MIAMI-DADE COUNTY

The Miami-Dade Water and Sewer Department and this Department's Code Coordination & Environmental Initiatives Division find the Application for Development Approval to be deficient and note that additional information is required:

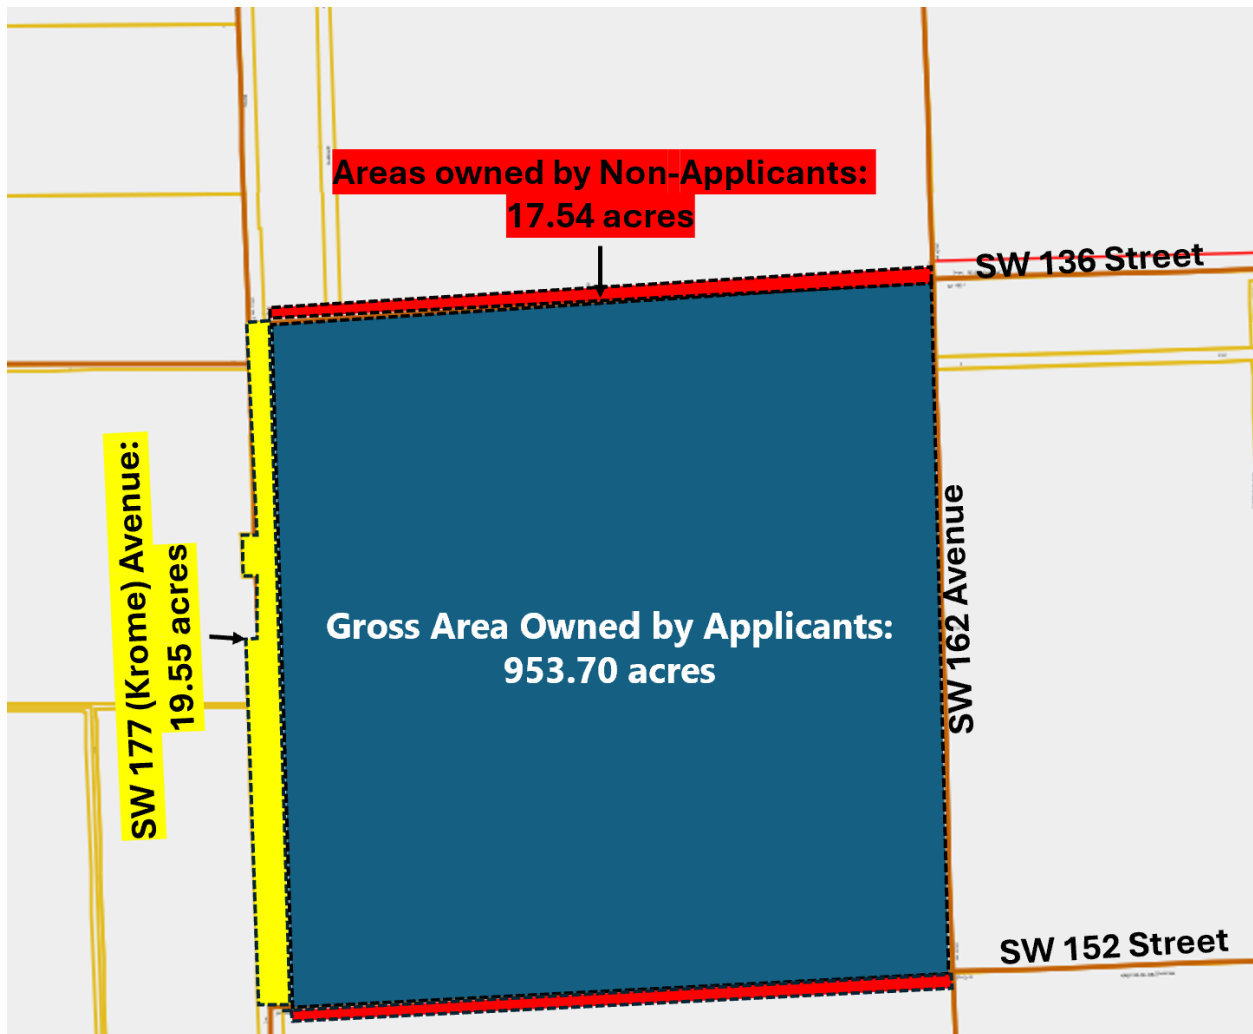
9. Page 10-1: The reported acreage is inconsistent between the DRI and the CDM applications. Please clarify and confirm the correct gross and net acreage of the application site to ensure consistency across all documents submitted to the County and to SFRPC.

Response: The application site consists of three different components that make up the “Total Application Area:” 1) the land owned by the Applicant; 2) lands abutting the south half of theoretical SW 152 Street and the north half of theoretical SW 136 Street that are zoned rights of way owned by non-applicants; and 3) lands dedicated and/or developed as Krome Avenue.

Total Gross Application Area	990.79 acres
Total Net Application Area	931.14 acres
Gross Area Owned by Applicants	953.70 gross acres (931.14 net acres)
Area Owned by Non-Applicants	17.54 acres (0 net acres – all zoned right of way)
Area of Krome Avenue between SW 136 ST and SW 152 Street	19.55 acres (0 net acres – all existing right of way)

The portions of the Total Application Area owned by Applicants, owned by non-applicants, and consisting of Krome Avenue are illustrated below.
